From: [Yu, Olivia, EMNRD](#)
To: ["Wright, Justin K"](#)
Cc: [Oberding, Tomas, EMNRD](#)
Subject: Response to RPs discussed on 3/14/2017 meeting
Date: Friday, March 17, 2017 3:49:00 PM

1RP-4233: EVGSAU 3366-029

CONOCOPHILLIPS
EVGSAU 3366-029

1RP-4233

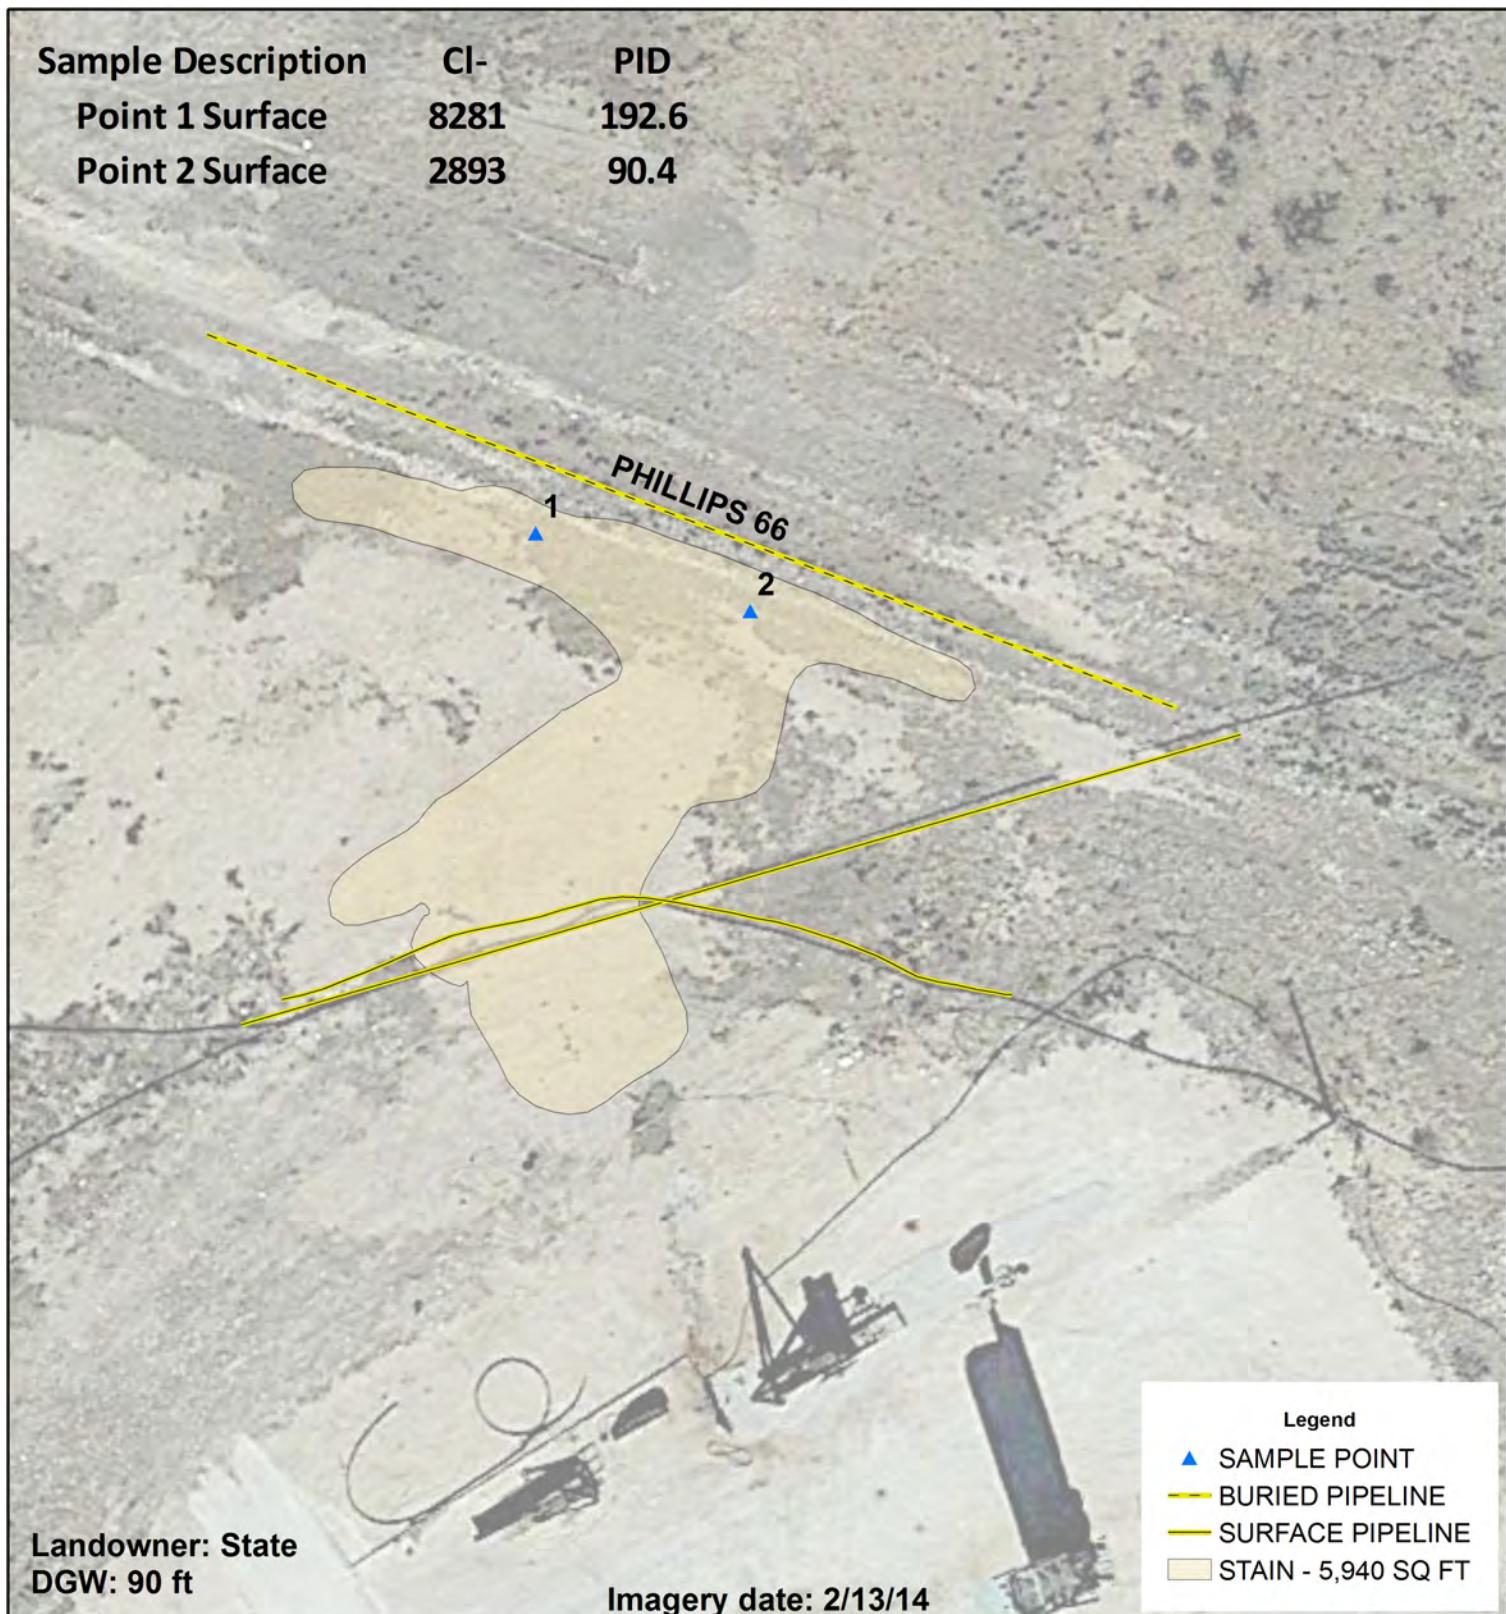
- Complete vertical delineation is required at all 4 sample locations to 250 mg/kg chloride and maintained for an additional 10 ft. below. For BTEX and TPH, obtain permissible levels and maintained for 3 ft. below. Confirmation bottom samples must have laboratory analyses.
- Provide all field data and all laboratory data must have corresponding field data for correlation.
